REVISION B - ADDENDUM NO. 2 - 4/27/12  
 REVISION A - ADDENDUM NO. 1 - 3/21/12

TENNESSEE VALLEY HEALTHCARE SYSTEM MURFREESBORO CAMPUS	Drawing Title	Project Title		Date
	<b>DEMOLITION FLOOR PLAN</b>	<b>REPLACE ATTIC AHU'S BUILDING 6</b>		01/20/2012
Approved: --	Approved: Facility Manager	Building Number	Checked	Drawn
Approved: --	Approved: Director	<b>6</b>	TCT	SNP
Location		FILE NAME	DRAWING NO.	
TVHS - YORK CAMPUS		11027M01	<b>6-M2</b>

**ATTIC FLOOR PLAN**  
 MECHANICAL - DEMOLITION  
 0 2 4 6 8 16  
 GRAPHIC SCALE (FEET)

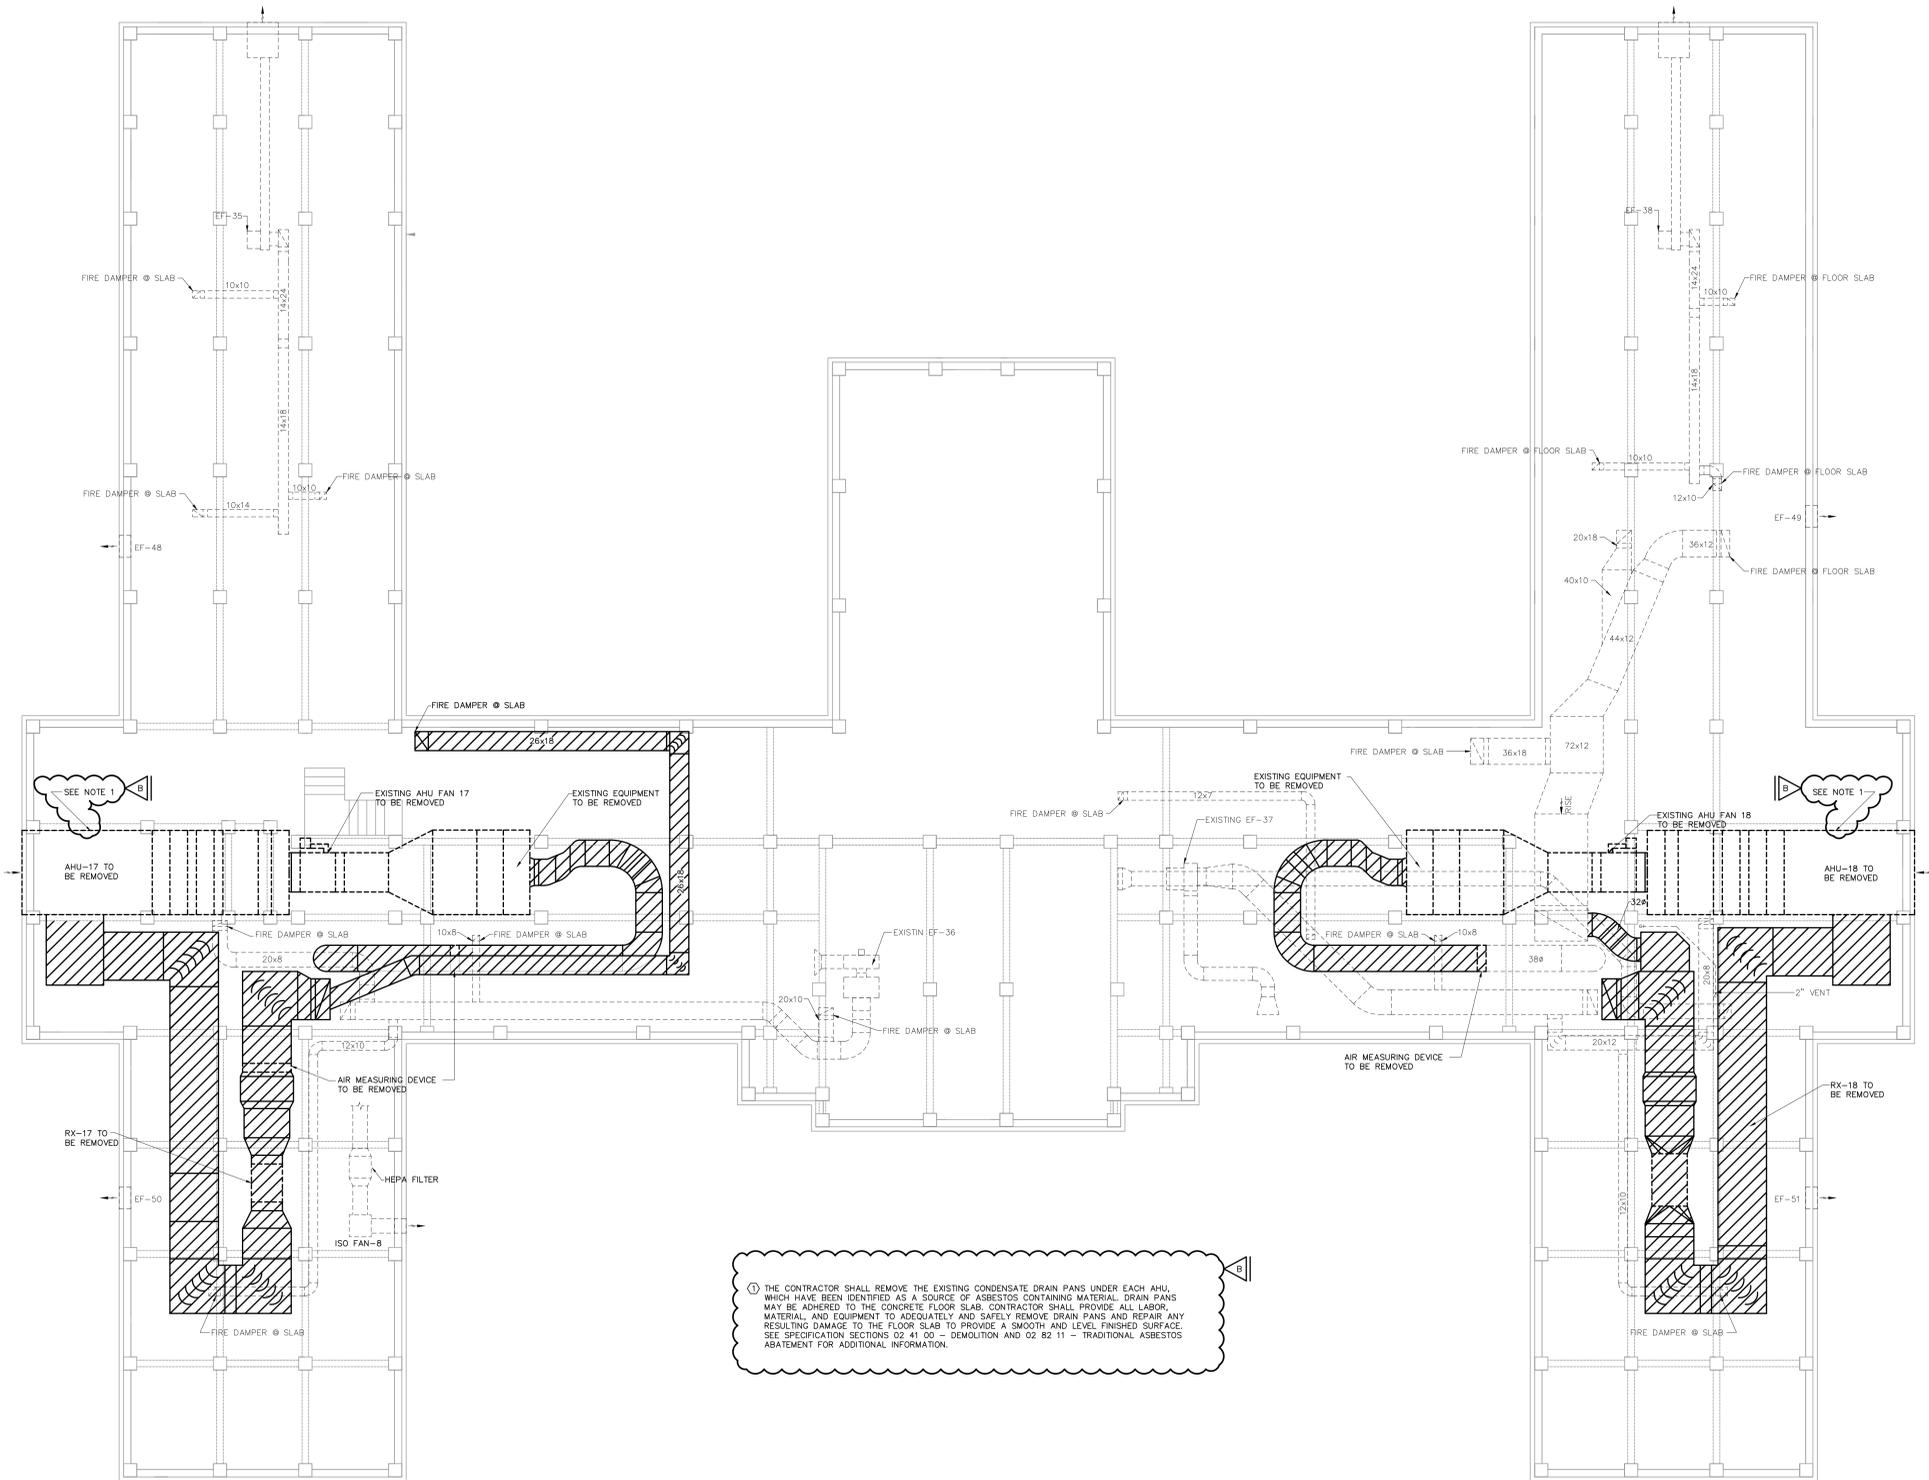
① THE CONTRACTOR SHALL REMOVE THE EXISTING CONDENSATE DRAIN PANS UNDER EACH AHU, WHICH HAVE BEEN IDENTIFIED AS A SOURCE OF ASBESTOS CONTAINING MATERIAL. DRAIN PANS MAY BE ADHERED TO THE CONCRETE FLOOR SLAB. CONTRACTOR SHALL PROVIDE ALL LABOR, MATERIAL, AND EQUIPMENT TO ADEQUATELY AND SAFELY REMOVE DRAIN PANS AND REPAIR ANY RESULTING DAMAGE TO THE FLOOR SLAB TO PROVIDE A SMOOTH AND LEVEL FINISHED SURFACE. SEE SPECIFICATION SECTIONS 02 41 00 - DEMOLITION AND 02 82 11 - TRADITIONAL ASBESTOS ABATEMENT FOR ADDITIONAL INFORMATION.
